## **Wagga Wagga Hospital Stage 3 Redevelopment**

### **Acoustic Brief**

**WWH-ALC-RPT-AC-GEN-0000001(D)**

### ARCHITECTURAL SERVICES GENERAL ARRANGEMENT PLAN - LEVEL 2

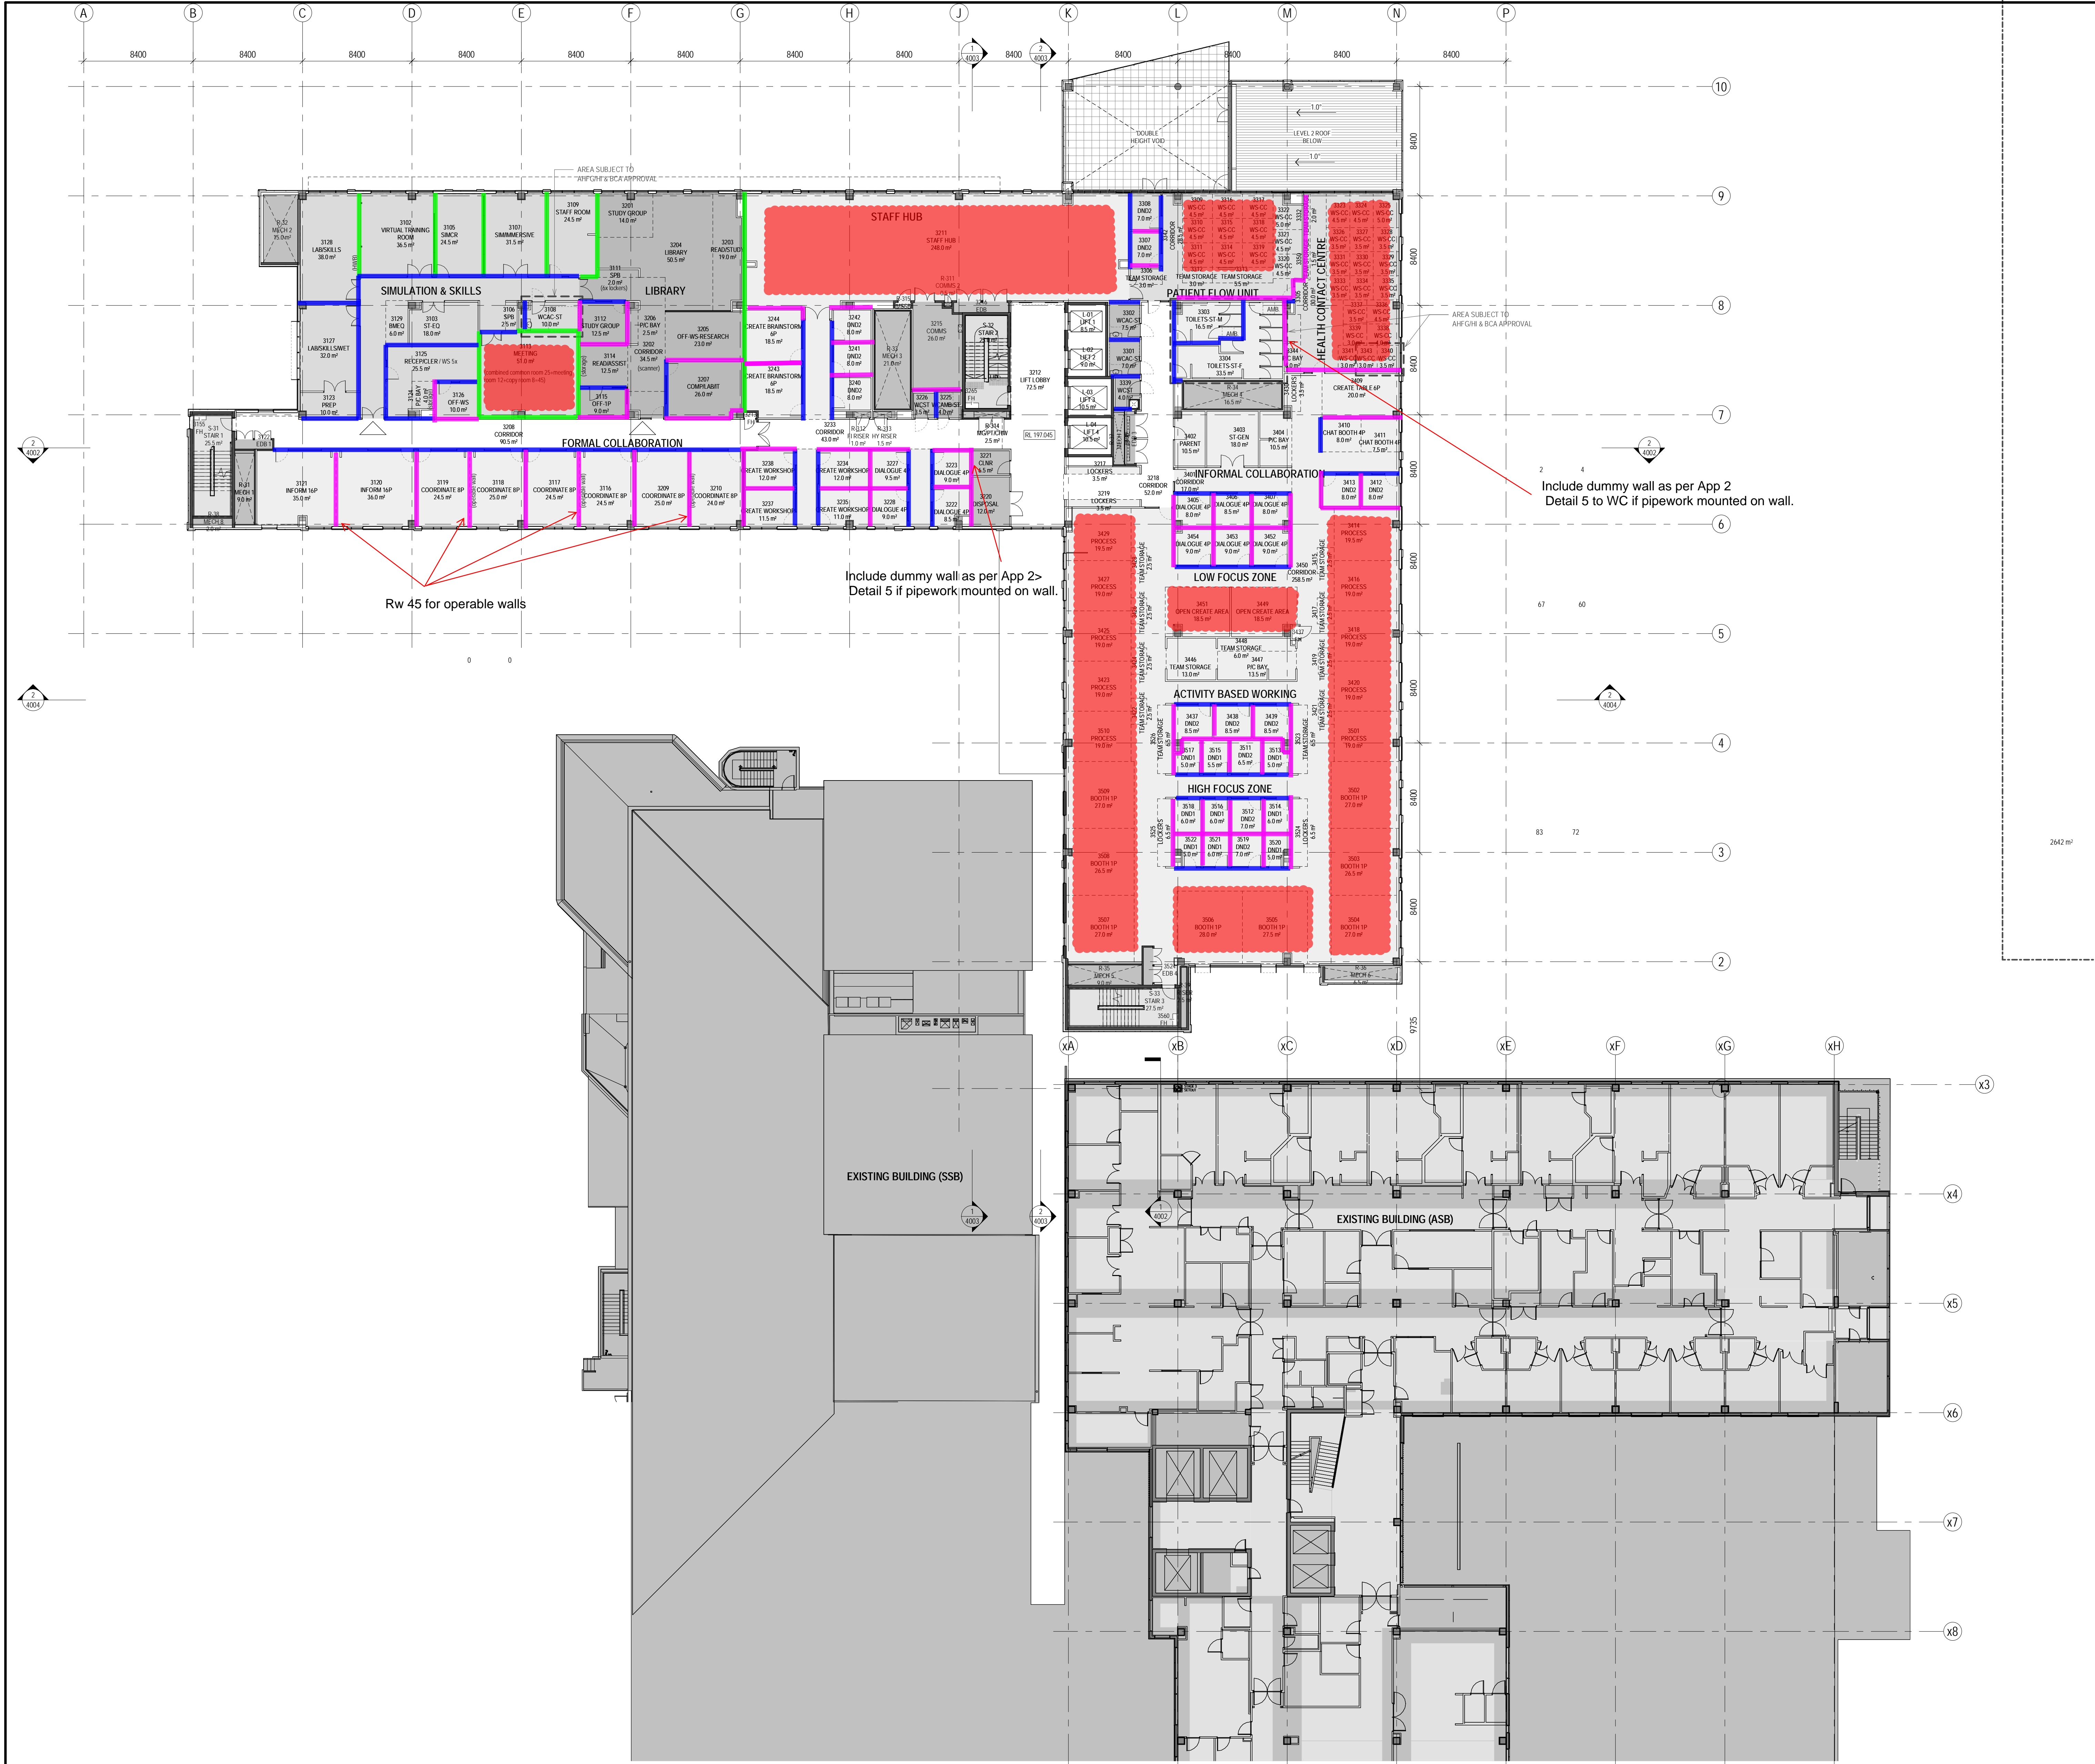
Include dummy wall as per App 2  
Detail 5 to WC if pipework mounted on wall.

Include dummy wall as per App 2-  
Detail 5 if pipework mounted on wall.
